Application to Amend Vista Ridge Drilling and Operating Permit No. POS-D&O and Transport Permit No. POS-T-0001d

Outline

Permitted Well Site

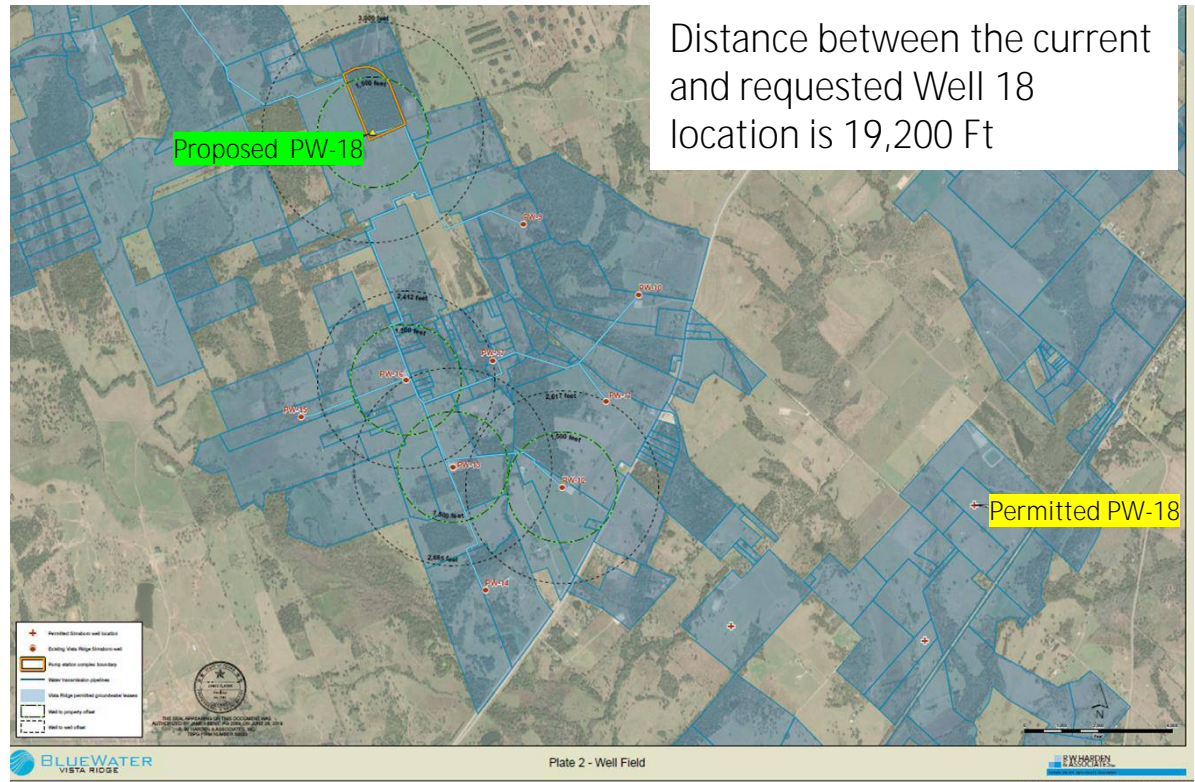
4.1.7 Upon application, and approval by the District, a well location established by permit may be modified on the request of both the permittee and the surface owner of land within the contiguous area included within the permit, or for the purpose of relocating the well to a site that is more secure from flooding, adverse drainage or any source of potential contamination.

Difference in 2050 Drawdown between Proposed and Permitted PW-18

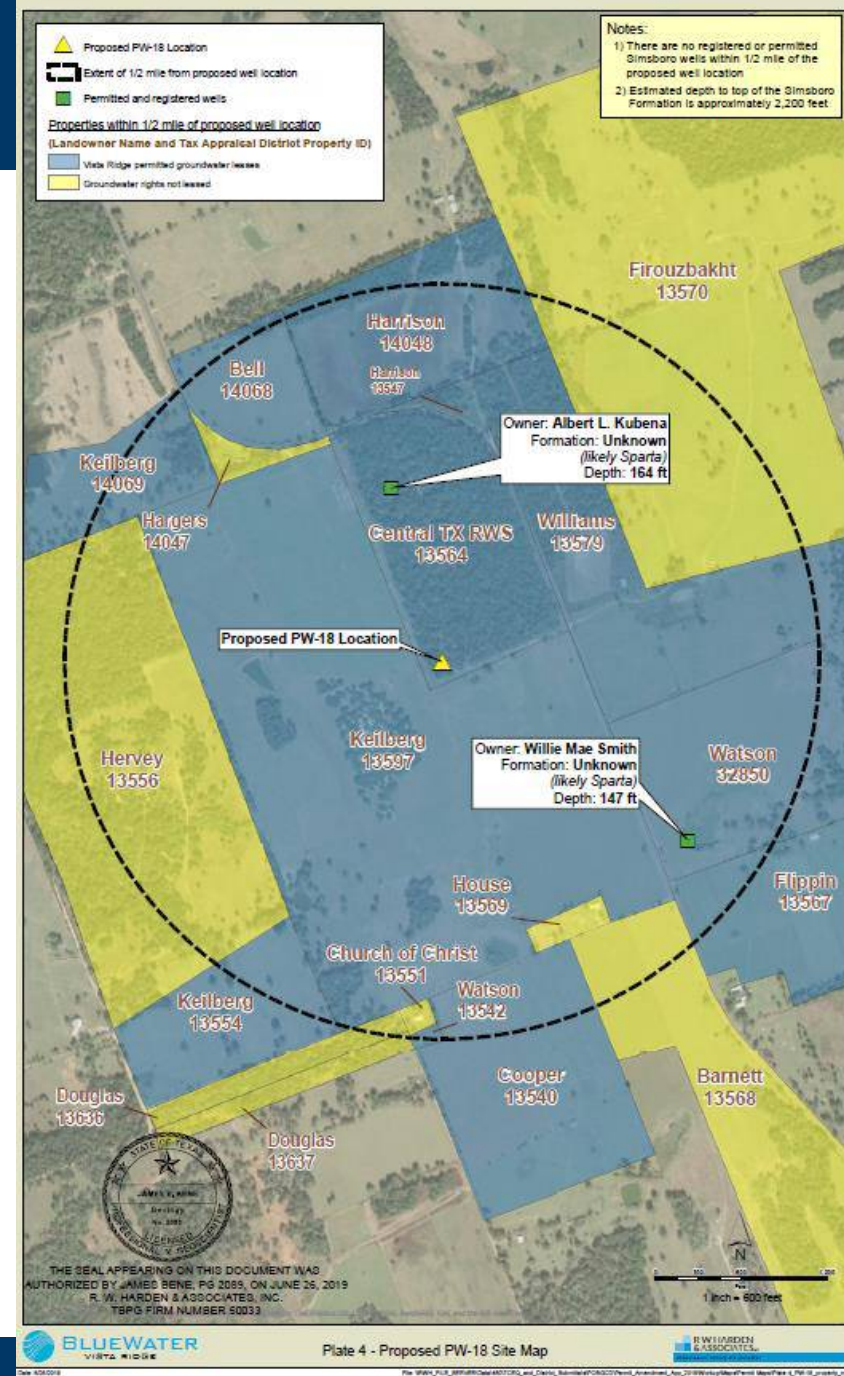
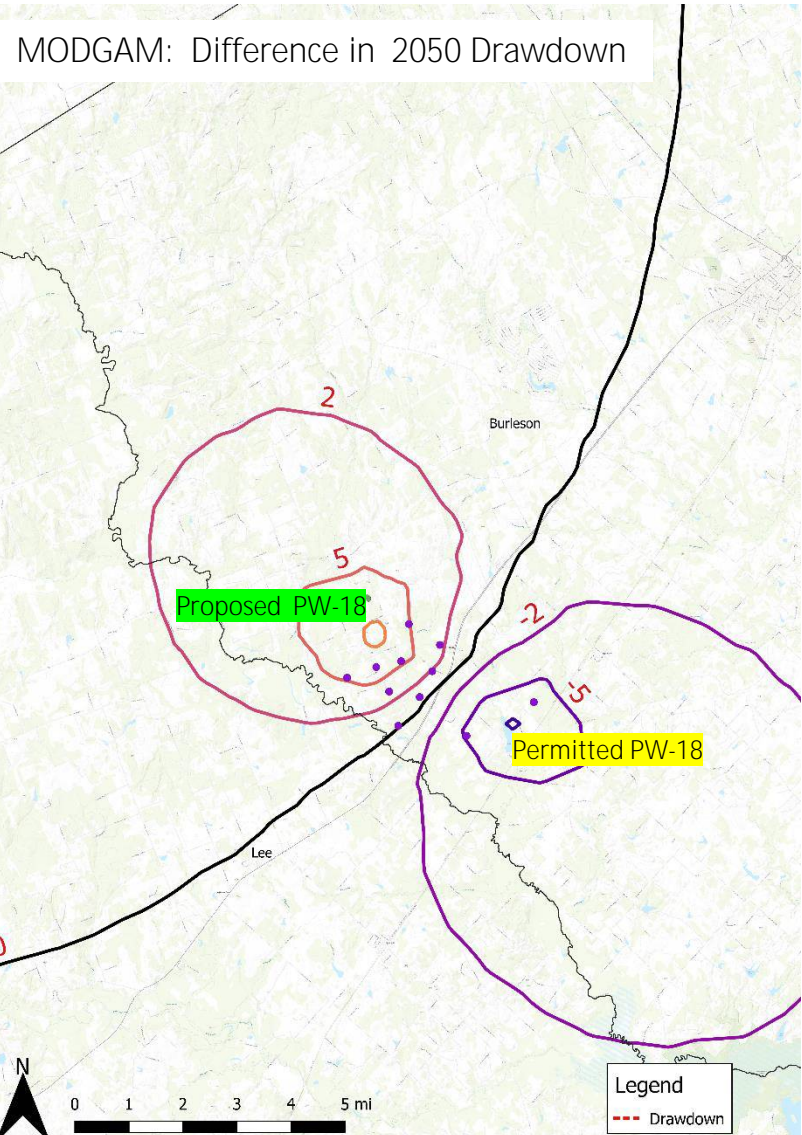
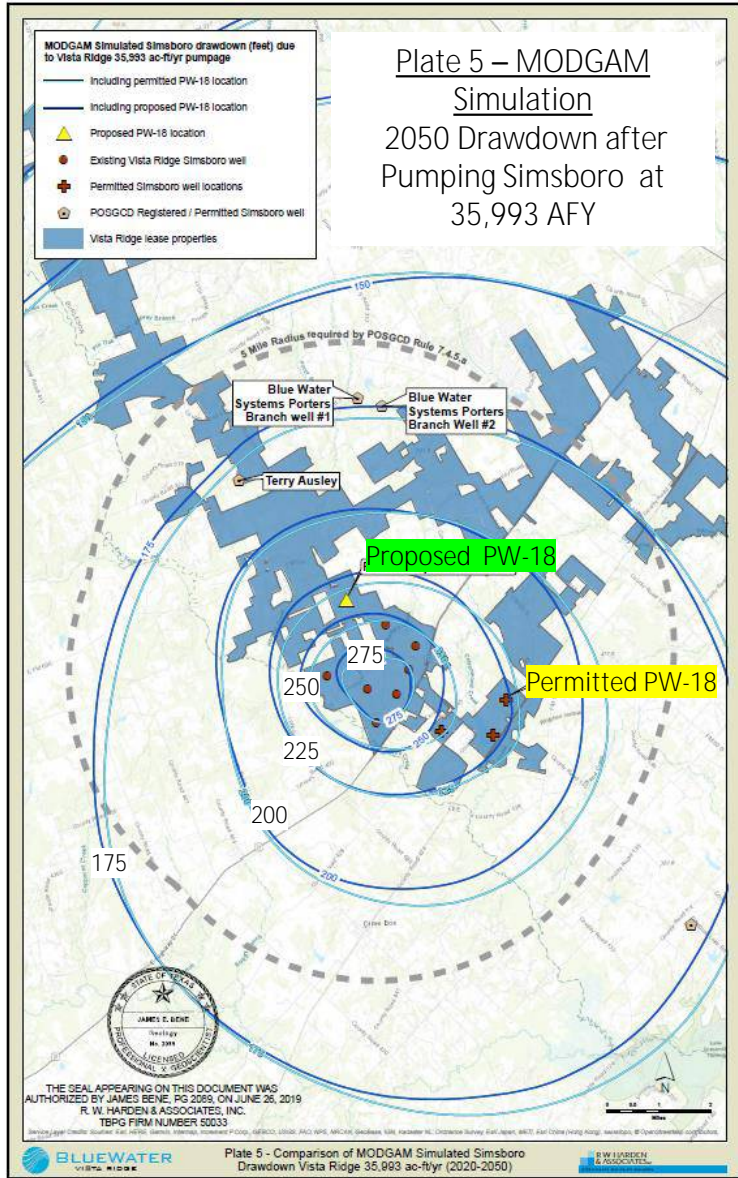
- Well spacing for proposed PW-18
 - achieved for property boundary
 - achieved for existing wells
- Maximum difference in simulated 2050 drawdown is less than 25 feet for GAM and MODGAM
- 25 feet is 1% change in available drawdown

Findings Regarding Subsidence

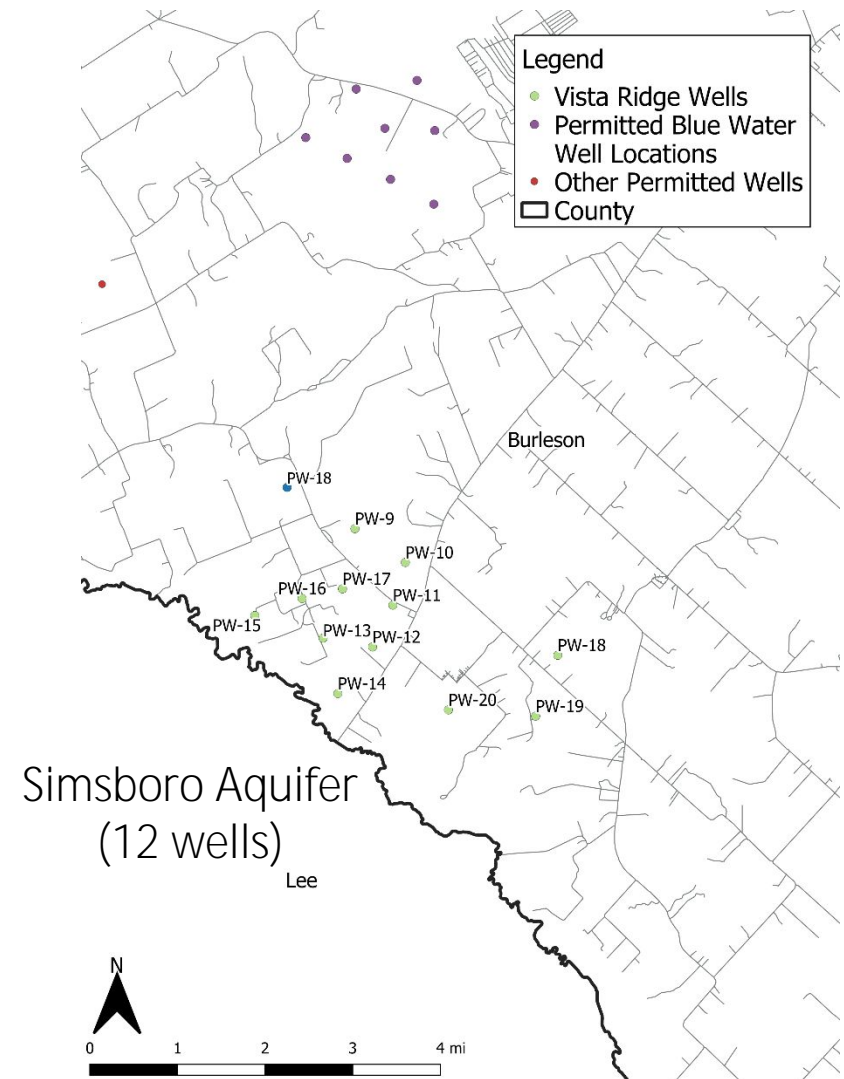
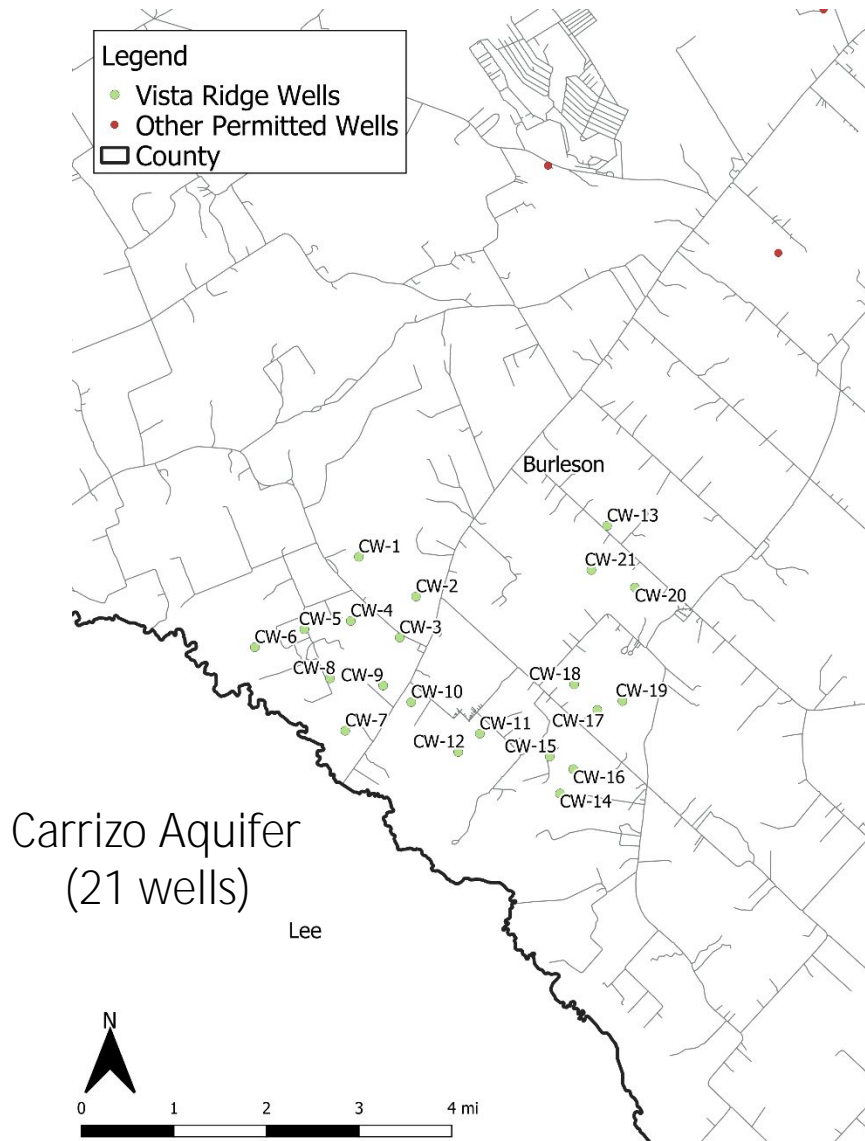
- Applicant states that estimates are provided “in interest of completeness” of application because
 - Large-scale pumping has been occurring for by cities of Bryan and College Station for decades without observable subsidence for problems associated with subsidence
 - TWDB tool will overpredict subsidence because GAM will overestimate drawdown in Calvert Bluff and Hooper because it does not properly account for stratification of clays in thick clayey formation
- Subsidence Predictions
 - Application provided estimate of land subsidence for cumulative Vista Ridge Pumping
 - Estimated Subsidence maximum cumulative for Vista Ridge pumping
 - Max 1.4 to 2.6 ft over 30 years
 - Over 50% compaction from Calvert Bluff
 - Need to estimate land subsidence for incremental permit amount of 4,842 AFY
